## DESCRIPTIVE REPORT

Field No. 742-10-3-63 Office No. H-8750

General locality Galveston Bay

OFFICE OF MARINE SURVEYS AND MAPS  
MARINE CHART DIVISION  
HYDROGRAPHIC SURVEY REVIEW

OVERLAY TO ACCOMPANY ECFP 10-3-63 H-8750  
 27 JAN. 1966 from pos. 47g to pos 70g Vol. 17 AND 18 SKIFF 520

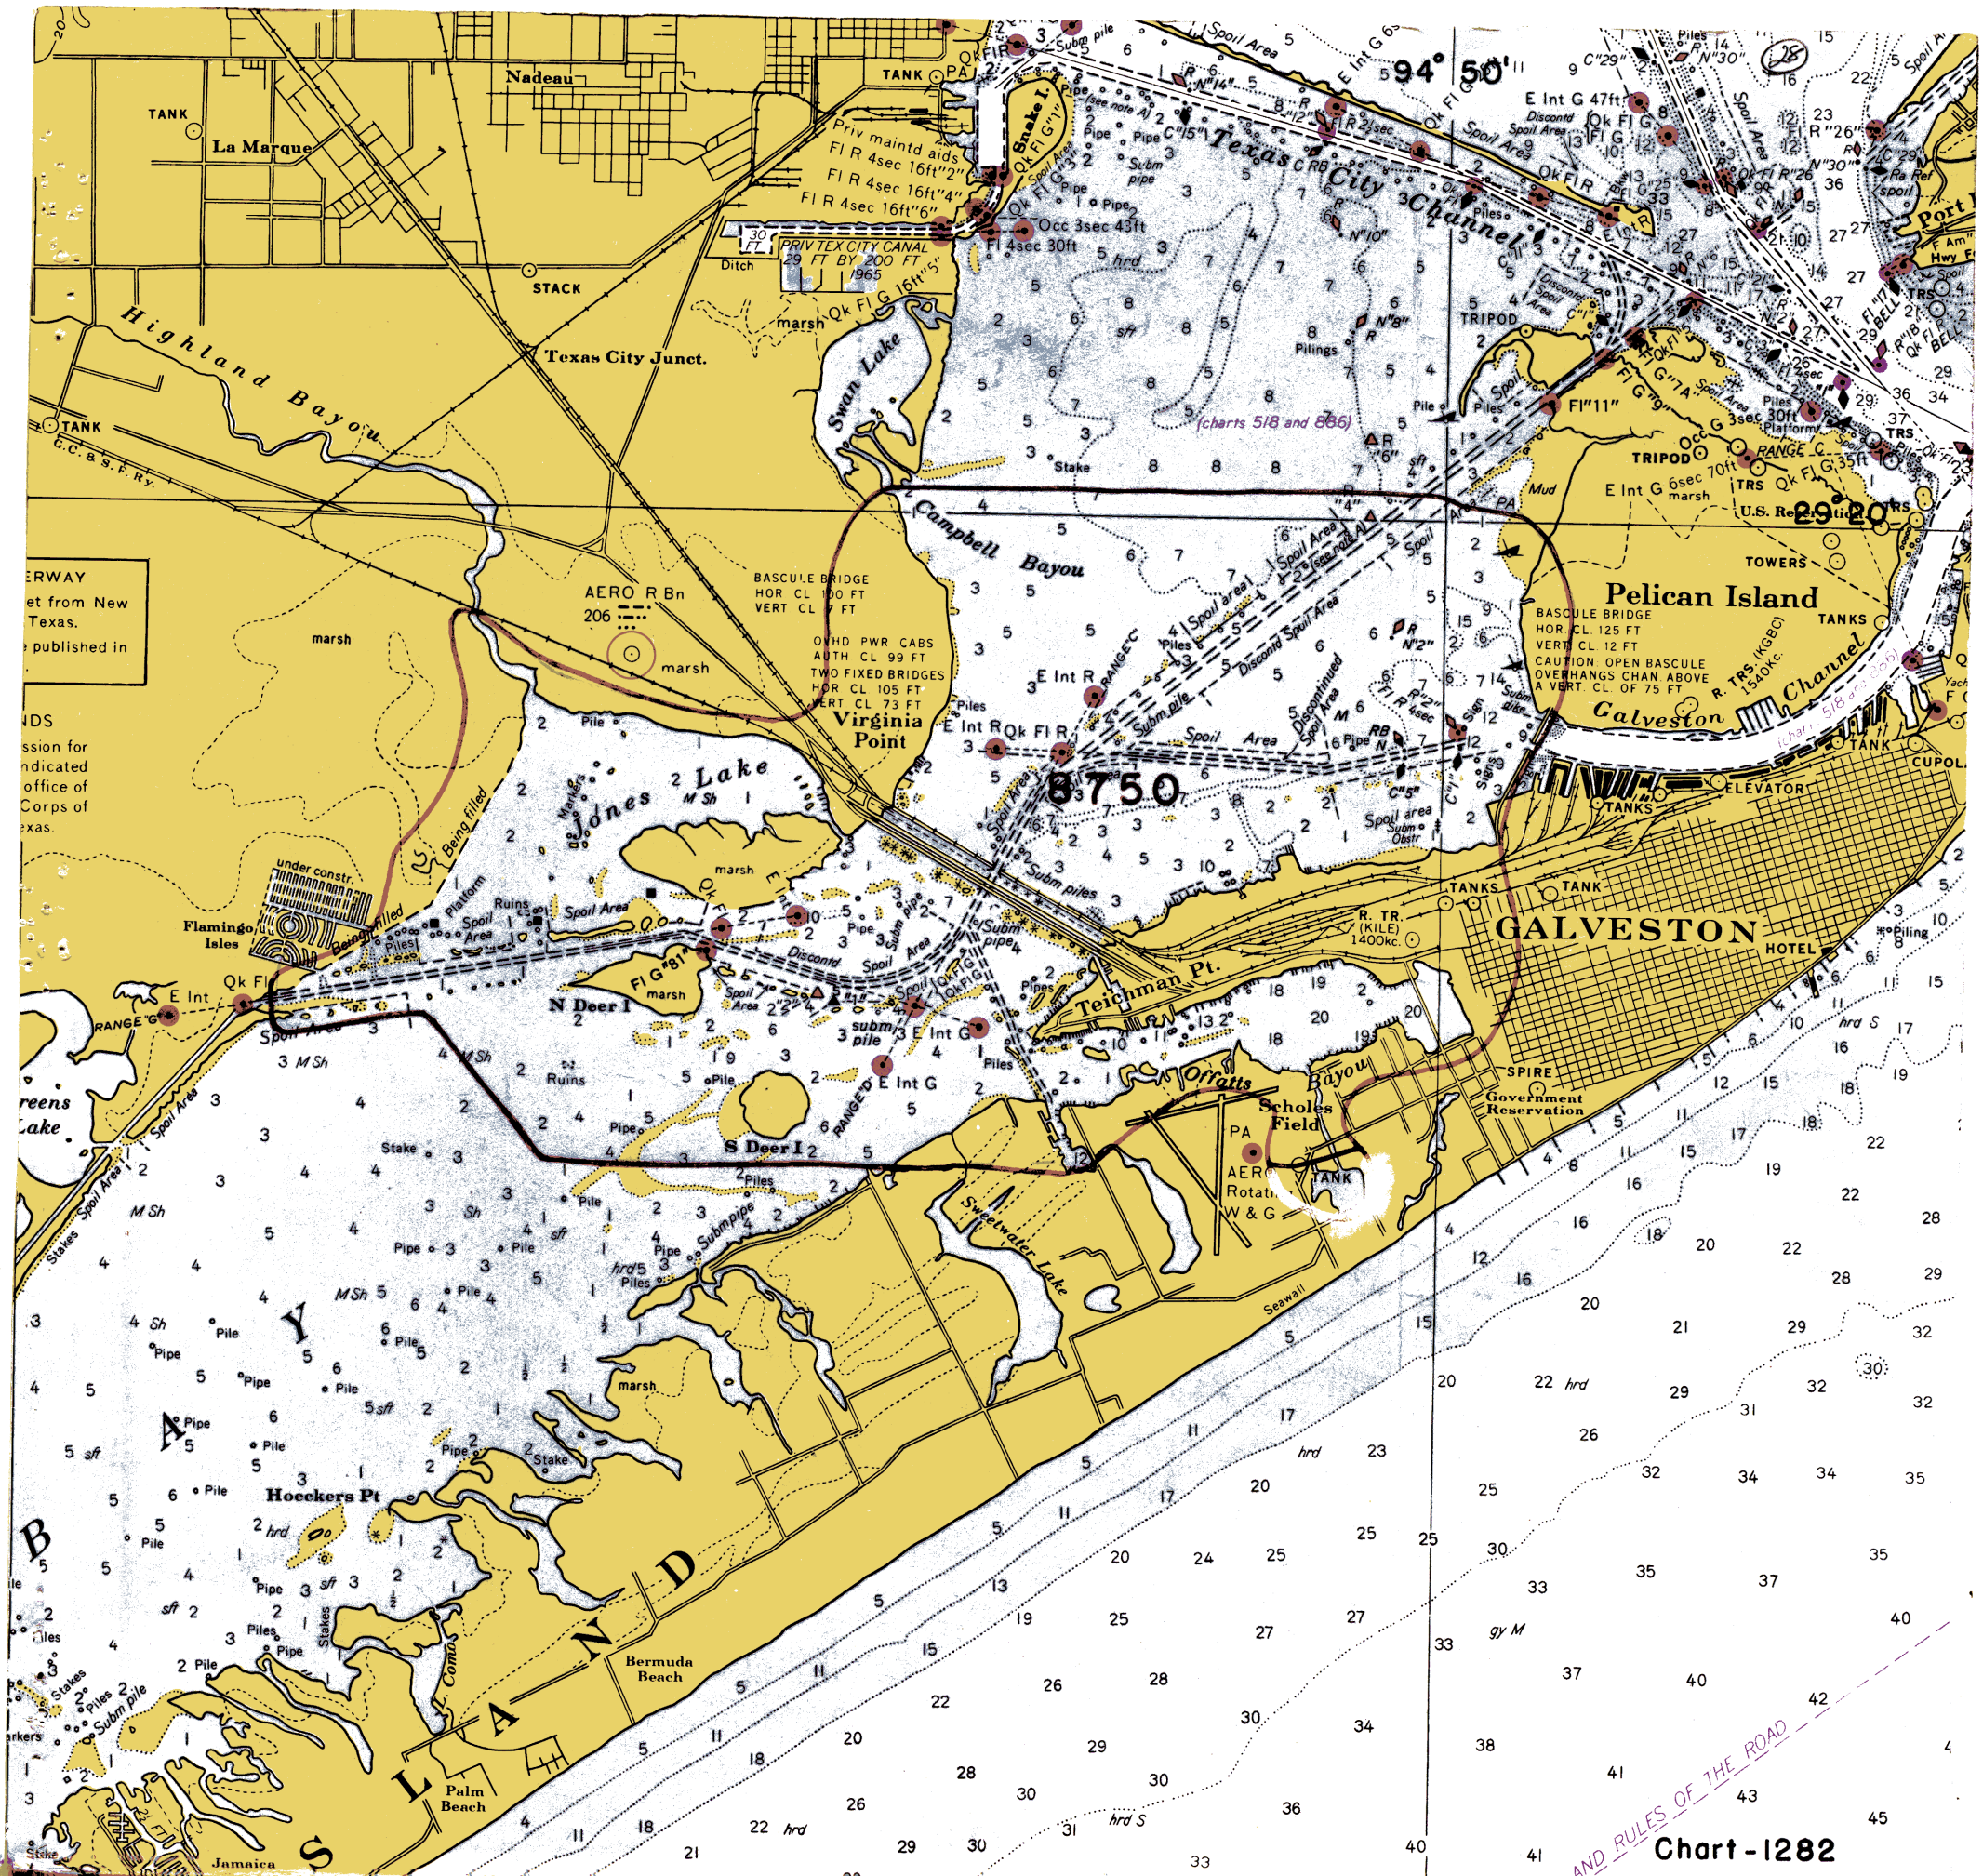
Positions 47 thru 70g (purple) are being submitted on a smooth overlay to avoid congestion on the smooth sheet.
